Re: Addendum No. 1 to the South Orange County Reliability Enhancement Project Minor Project Refinement No. 1.

Addendum No.1 to MPR-1 Request for Approval

**MPR-1 FIGURE 1 ADDENDUM
SAN JUAN CAPISTRANO SUBSTATION**

South Orange County Reliability Enhancement Project CPUC Minor Project Refinement Form

ATTACHMENT B
MPR-1 Addendum Site Photographs

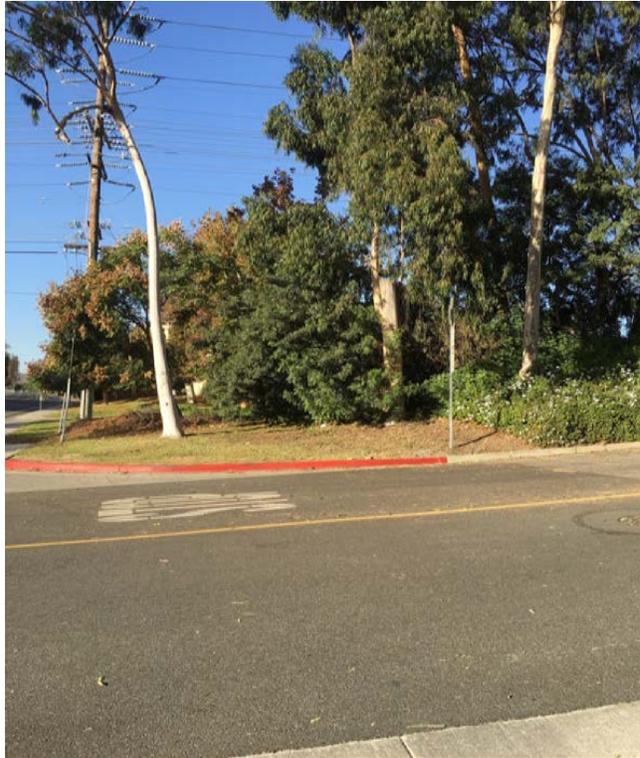
The approximate 24-foot wide driveway would be established along with a 20-foot wide chain link security gate. The driveway would be created through the use of Class-II base and asphalt would be used to create a lip over the existing curb on Calle Bonita; however, the details regarding construction of the driveway would be coordinated with the City of San Juan Capistrano through the encroachment permit process. SDG&E operations and maintenance personnel would use the access through approximately May 2021, while construction activities in the 138/12 kV yard are occurring at the site. Phase 2 construction access would continue until the completion of the work in the upper yard anticipated 2022. At the completion of construction, and consistent with MPR-1, the temporary access driveway and gate would be removed and the temporary work area would be restored to pre-Project conditions or pursuant to agreements with the landowner.

Approximate location of
new temporary driveway
and gate.
